HISTORIC AND DESIGN REVIEW COMMISSION

February 03, 2021

HDRC CASE NO:	2021-023
ADDRESS:	113 LINDELL PLACE
LEGAL DESCRIPTION:	NCB 6201 BLK 2 LOT 21
ZONING:	R-4, H, RIO-1
CITY COUNCIL DIST.:	1
DISTRICT:	River Road Historic District
APPLICANT:	Seth Teel/TEEL AUDRA JANE
OWNER:	Seth Teel/TEEL AUDRA JANE
TYPE OF WORK:	Construction of a rear accessory structure
APPLICATION RECEIVED:	January 06, 2021
60-DAY REVIEW:	Not applicable due to City Council Emergency Orders
CASE MANAGER:	Edward Hall

REQUEST:

Materials:

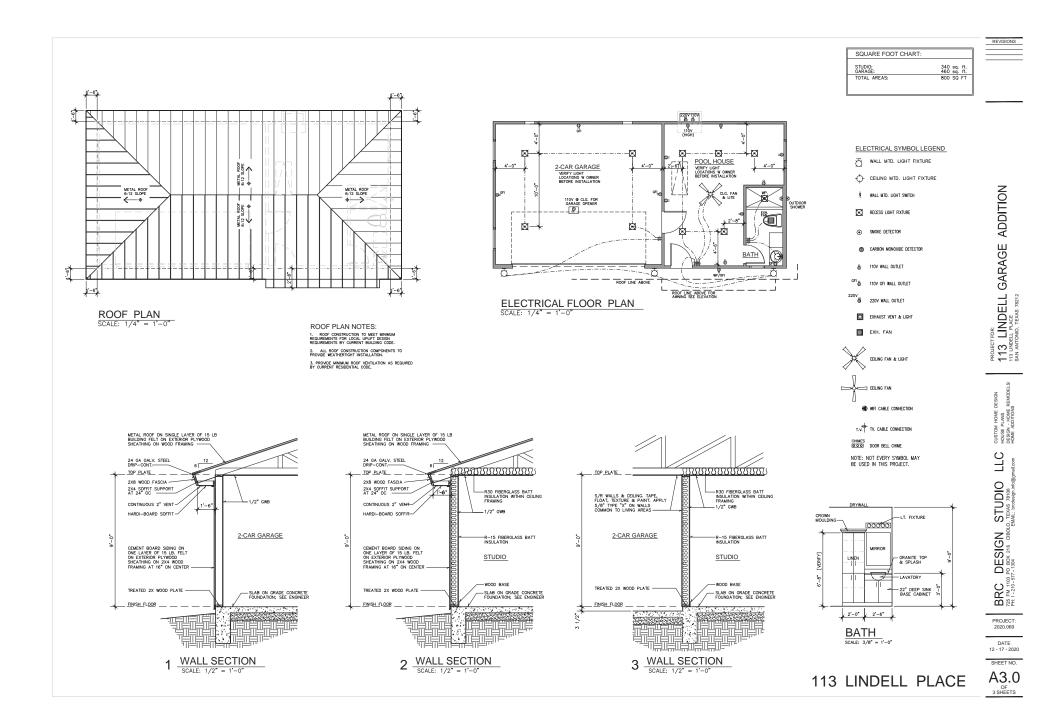
- d. ARCHITECTURAL DETAILS (Materials) The Guidelines for New Construction 5.A.iii. and iv. note that new accessory structures should relate to the period of construction of the primary historic structure on the lot through the use of complementary materials and simplified architectural details. The applicant has proposed composite siding and a standing seam metal roof. Staff finds the use of composite siding appropriate; however, staff finds that lap siding with a four (4) inch exposure would be more appropriate to relate to the horizontal wood siding of the primary historic structure. Additionally, staff finds that the composite siding should feature a smooth finish. The applicant has proposed corner trim to relate to that on the primary historic structure. Staff finds this to be appropriate. The proposed standing seam metal roof should feature smooth panels that are 18 to 21 inches in width, seams that are 1 to 2 inches in height, a crimped ridge seam or low profile ridge cap and a standard galvalume finish. If a low profile ridge cap is to be used, it is to be submitted to staff for review and approval.

- e. ARCHITECTURAL DETAILS (Garage door) The applicant has proposed for a double wide garage door, but has not specified the materials. Staff finds that double width garage doors are not found historically within the district. Staff finds that two, single width garage doors should be installed to feature wood or metal construction to feature windows.

- 1. Staff recommends approval of item #1, the construction of a rear accessory structure based on findings b through e with the following stipulations:
 - i. That the composite siding feature an exposure of four (4) inches and a smooth finish.
 - ii. That the applicant install two garage doors to feature with wood or metal construction and windows rather than one door, as proposed.
 - iii. That the standing seam metal roof feature panels that are 18 to 21 inches in width, seams that are 1 to 2 inches in height, a crimped ridge seam or low profile ridge cap and a standard galvalume finish. If a low profile ridge cap is to be used, it is to be submitted to staff for review and approval.
